| Project | IEEE 802.16 Broadband Wireless Access Working Group < http://ieee802.org/16 > | |
| Title | DIUC/UIUC provision for supporting multiple advanced FEC types | |
| Date Submitted | 2005-05-04 | |
| Re: | This is a response to a Call for Comments on IEEE P802.16e-D7 | |

Figure 1. DIUC division for supporting several FEC types

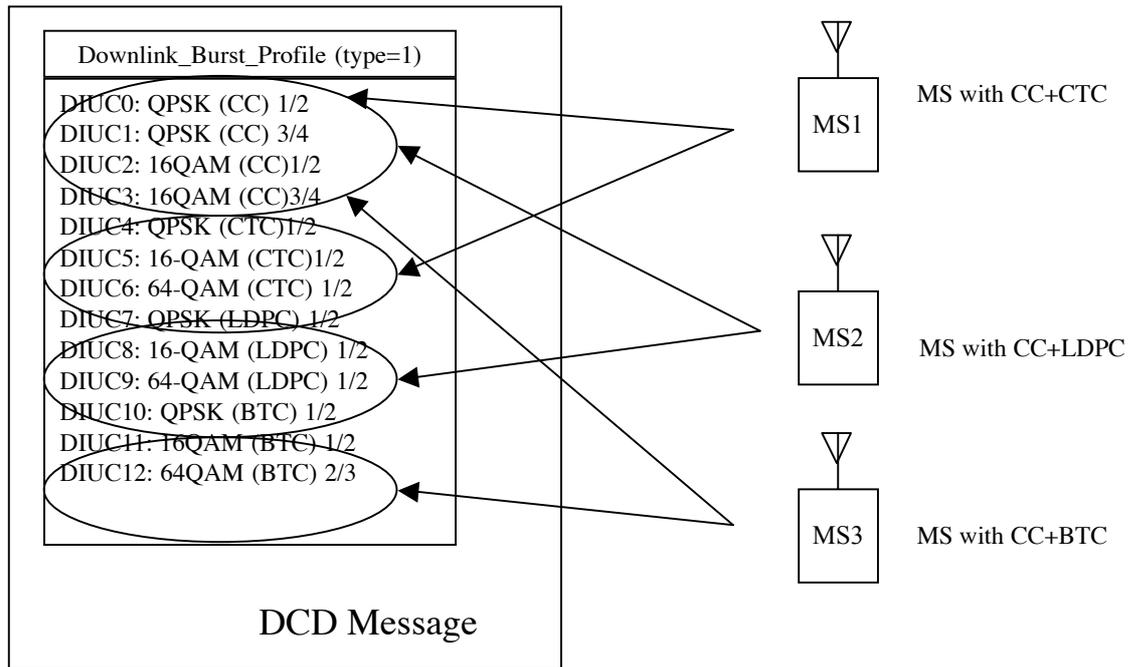
The current specification includes several FEC types such as CC(mandatory), BTC(optional), CTC(optional), ZT CC(optional) and LDPC(optional), and defines 41 burst profiles e.g., QPSK(CC) 1/2, 16QAM(CTC) 2/3 and so on (see Table 361) where each FEC type has about 6~15 burst profiles. BS selects and allocates 13 burst profiles among 41 burst profiles onto DIUC0 through DIUC12 and 10 burst profiles onto UIUC1~UIUC10, and announce it through the DCD/UCD messages. When the cell includes MS's having different FEC types, DIUC0~DIUC12 should support these FEC types and it makes one FEC type get small room of MCS levels. For example, when three MS's within a cell have CC+CTC, CC+LDPC and CC+BTC respectively, each FEC type (CC, CTC, LDPC and BTC) should have only 3~4 DIUC's and 2~3 UIUC's as shown in Figure1. These numbers of DIUC/UIUC's are too small for fine link adaptation.

Figure 2. Proposed scheme for providing enough MCS levels i.e., DIUC/UIUC's for each FEC type

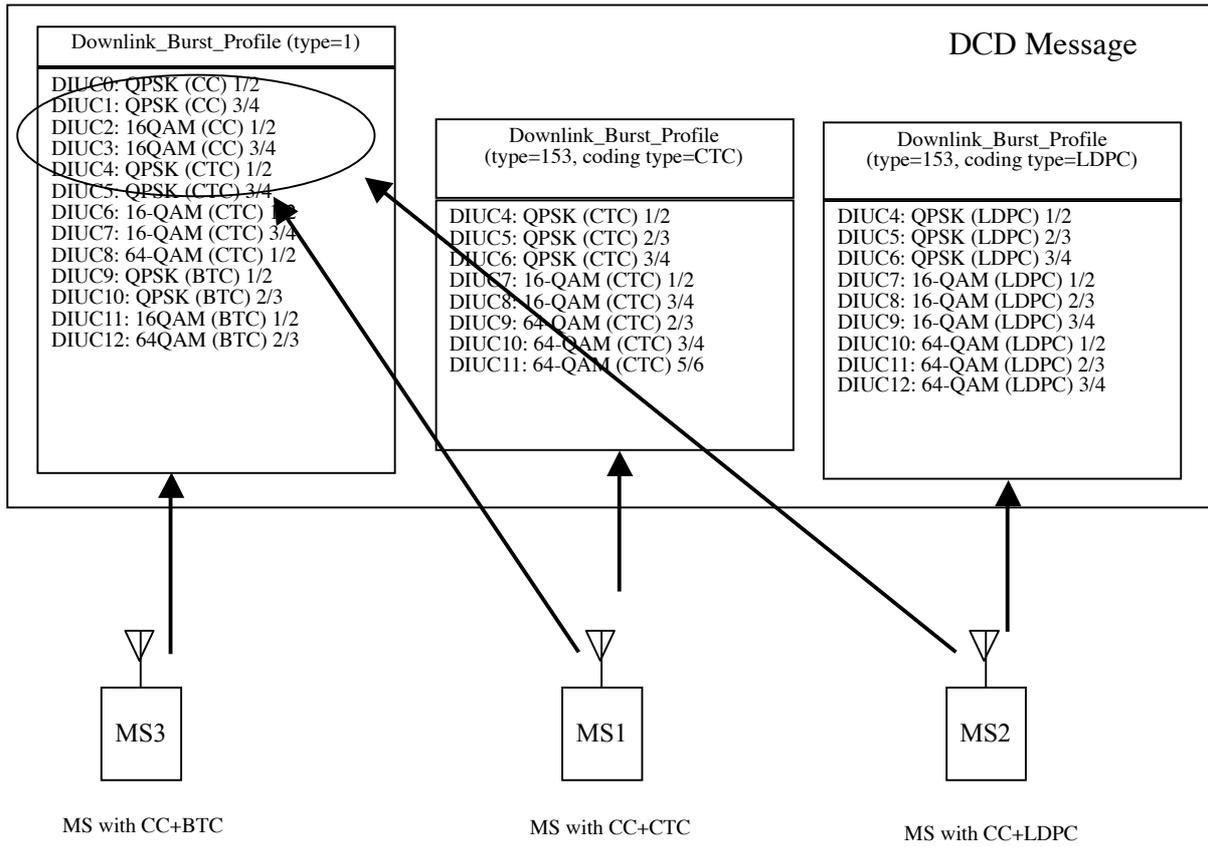
To provide more rooms for DIUC(UIUC) per each FEC type, we propose the downlink(uplink)_burst_profile with other type which are dedicated to each FEC type as shown in Figure 2. 802.16-2004 version MS refers to its DIUC(UIUC) set from the downlink(uplink)_burst_profile with type 1 and the later version MS can refer to its DIUC(UIUC) set from each downlink(uplink)_burst_profile with type 153(13) and downlink(uplink)_burst_profile with type 1 for CC. In Figure 2, DIUC10 can be interpreted as one of three meanings of QPSK (BTC) 2/3, 64-QAM (CTC) 3/4 or 64-QAM (LDPC) 1/2 according to FEC type of MS. When there is no downlink(uplink)_burst_profile with type 153(13), the whole MS's shall refer to their DIUC(UIUC) set from the downlink(uplink)_burst_profile with type 1.

Figure 3. SBC_RSP message to restrict MS to use just one optional FEC type

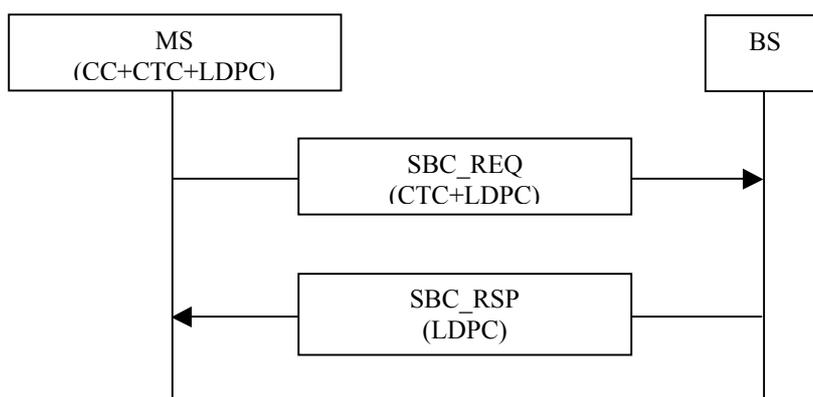
For example, when a MS was equipped two optional FEC such as CTC+LDPC, the proposed scheme results in confusion of DIUC(UIUC) definition. In this case, BS should restrict just one of two optional FEC types on the MS available after reception of SBC_REQ indicating that MS has CTC+LDPC capability. This restriction can be delivered to the MS through SBC_RSP message.

MS refers to DIUC/UIUC related to CC+LDPC
